From: SUNGJOO KIM
Sent: Wednesday, September 17, 2008 2:12 PM
To: PCTEST TCB
Subject: Re: Question Regarding FCC ID: A3LML2855ND
Importance: High
Attachments: LBE082431_ML-2855ND_FCC.pdf

Title : Question Regarding FCC ID: A3LML2855ND

RE: FCC ID: A3LML2855ND

Subject: Request for additional information

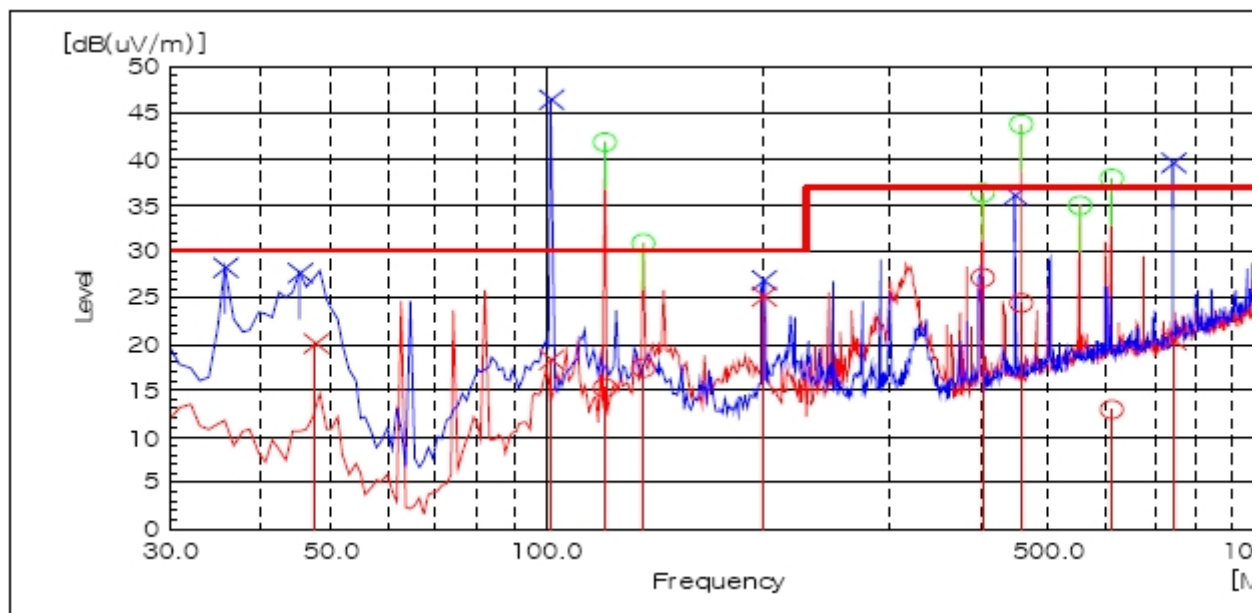
1. The test graph on p.30/40 of the test report appears to show multiple emissions, both peak and average, that exceed the limit. Please address.

(Ans) Points which shows over the limit are peak(Blue and Green mark) value not quasi-peak

or average value on page. 30.

There are no points of quasi-peak(red mark) which exess the limit.
